ADDENDUM NO. 02

Project: Stuhr Museum of the Prairie Pioneer

Project No.: L11019

Date: 01-27-14

1 FIRST FLOOR DEMOLITION PLAN - ADD 2.1

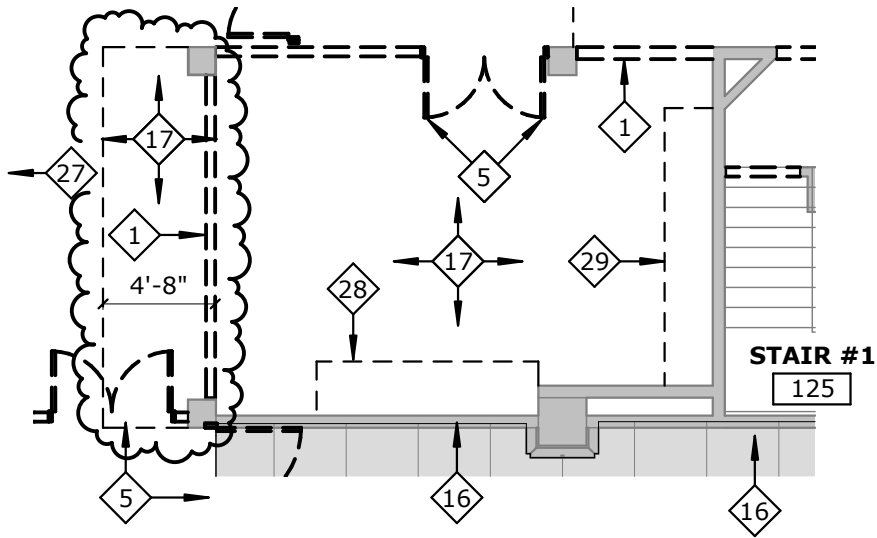
1. See Drawing Attachment “1” for added Demolition work. Refer to Sheet AD1.1.
2. See Drawing Attachment “2” for added Demolition work. Refer to Sheet AD1.1.
3. See Drawing Attachment “3” for revised ROOF EDGE DETAIL drawn on Sheet A1.13.
4. See Drawing Attachment “4” for revised FASCIA PANEL DETAILS drawn on Sheet A3.1.

2 FIRST FLOOR DEMOLITION PLAN - ADD 2B

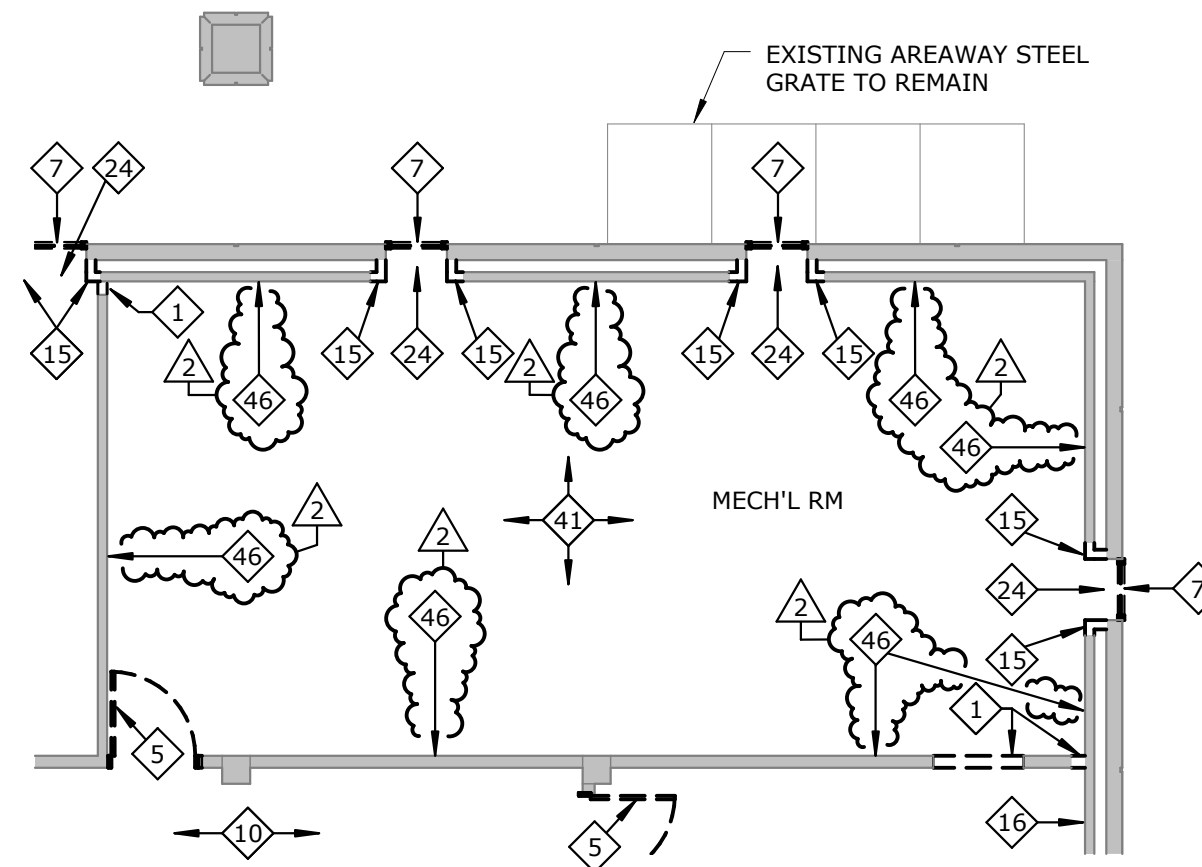
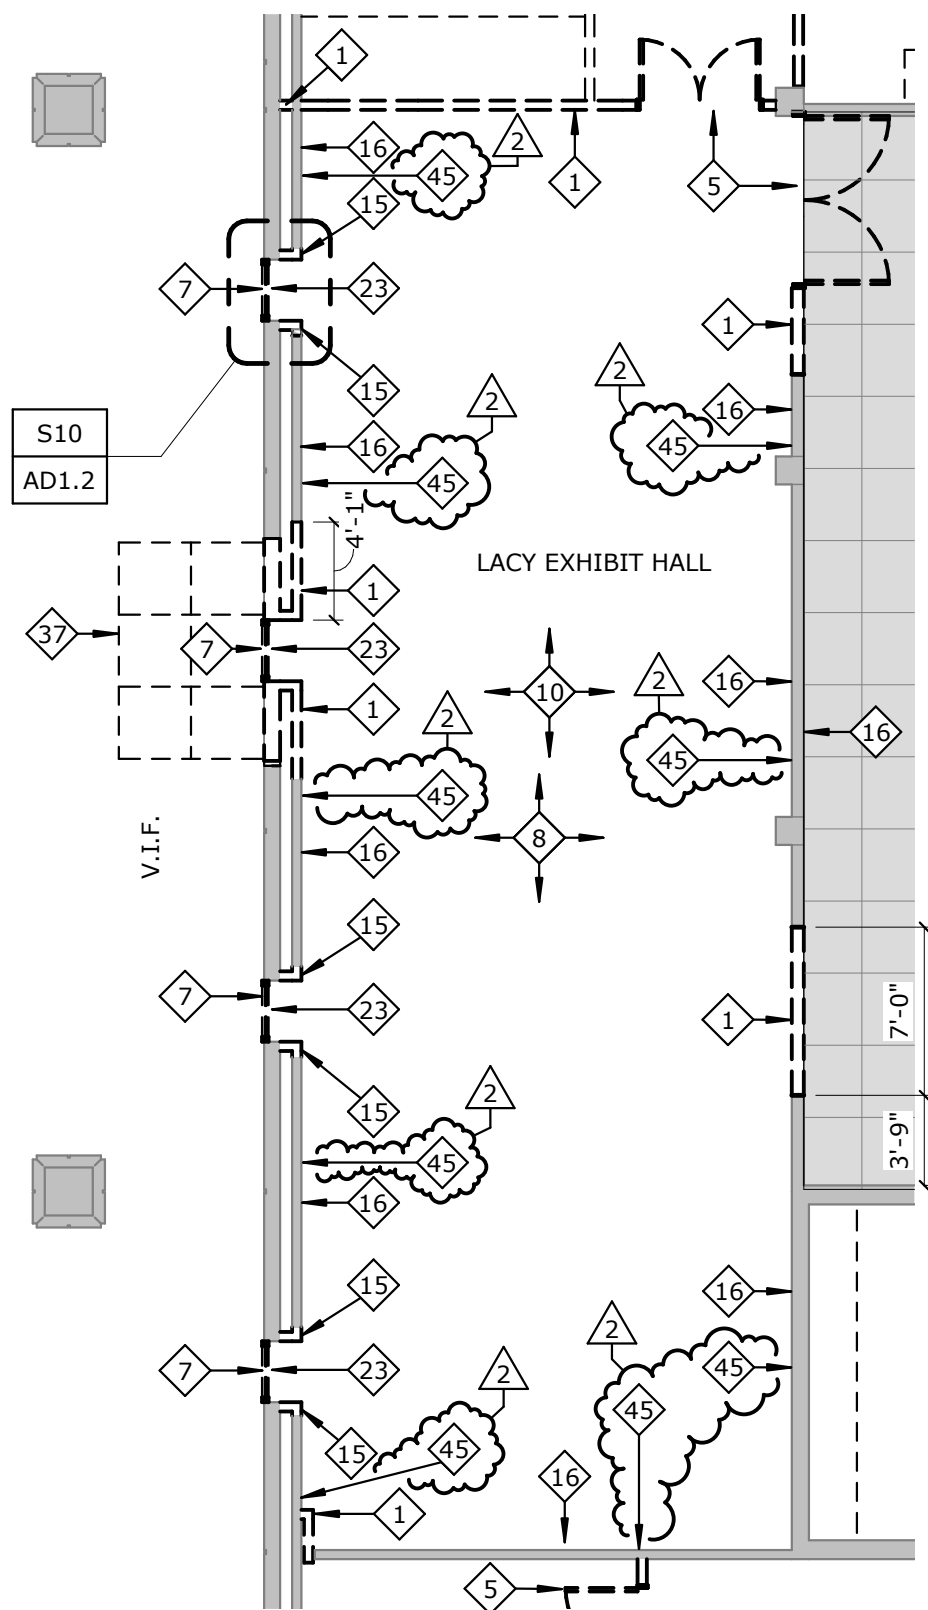
- 45 REMOVE EXISTING WALL CARPET IN ITS ENTIRETY AND ALL ADHESIVE RESIDUE AND FASTENERS FROM THE EXISTING WALL SUBSTRATE IN THIS ROOM.
- 46 REMOVE ALL EXISTING ACOUSSTICAL WALL TILES ONLY AND ADHESIVE RESIDUE IN THIS ROOM.

CAST STONE FASCIA SUPPORT

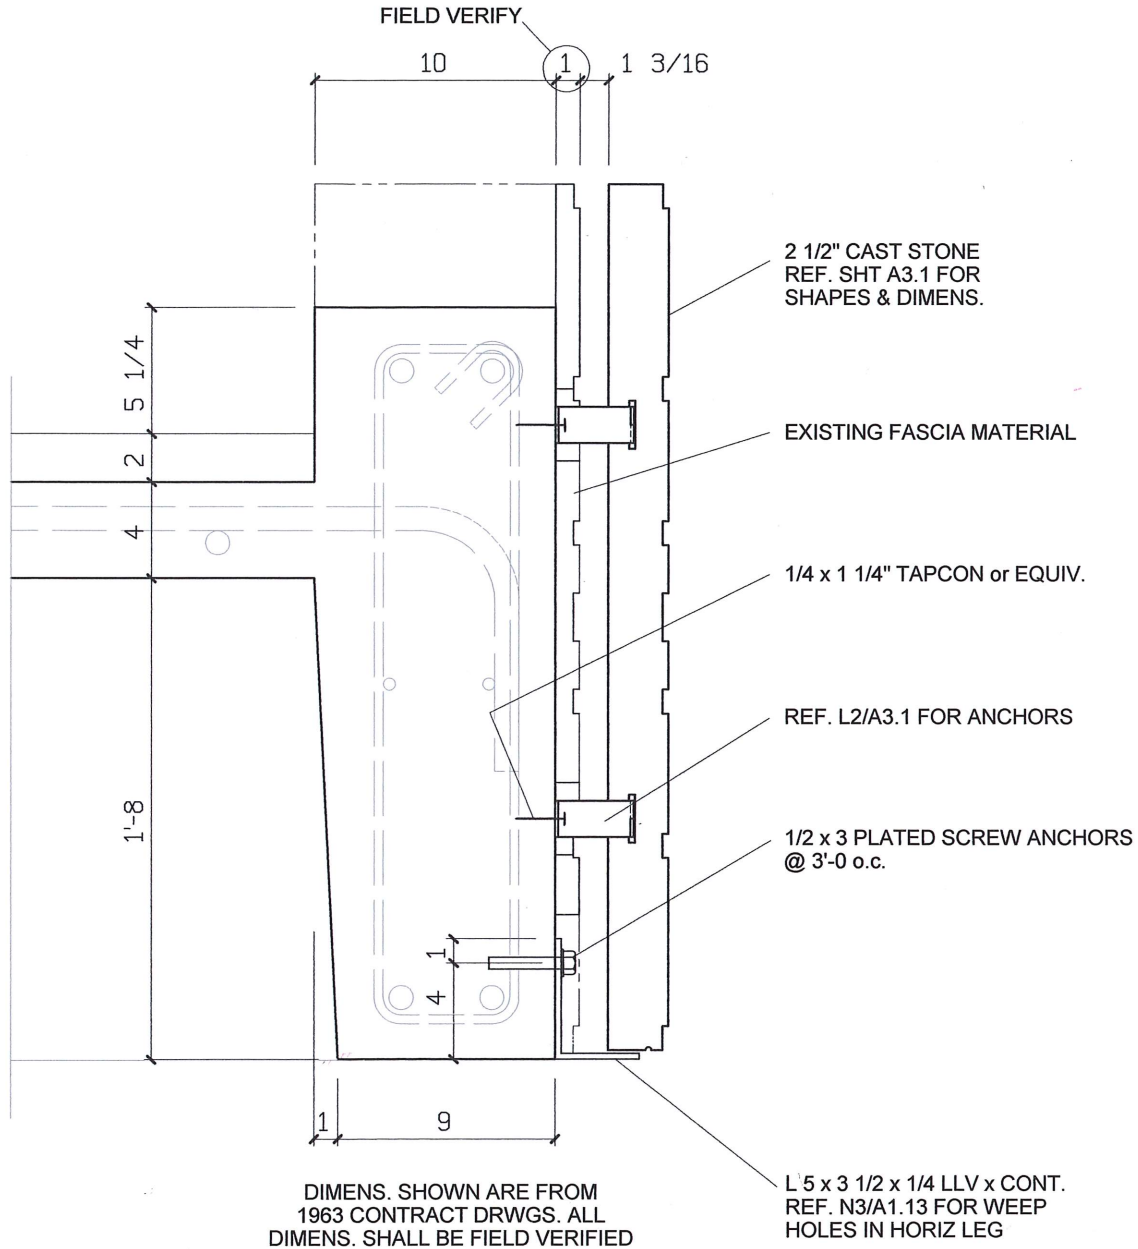
- 1 See the attached Structural Addendum No. 2 for CAST STONE FASCIA SUPPORT Detail.
